ADA Curb Ramp New Construction Inspection Form (Perpendicular)

Nw 315 th ave

24952.54

Nw Yorkshire st

PERPENDICULAR RAMP (PR)

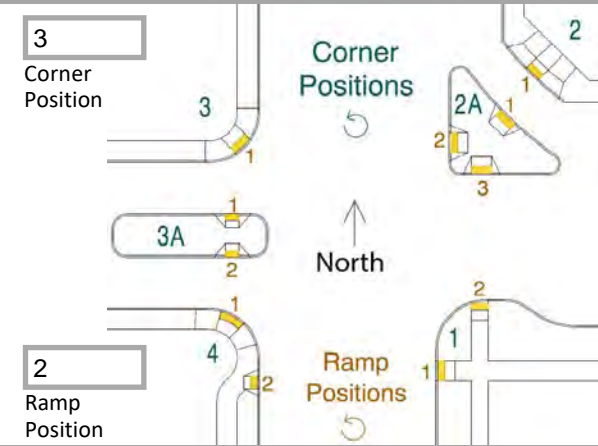
Crack thru curb and gutter
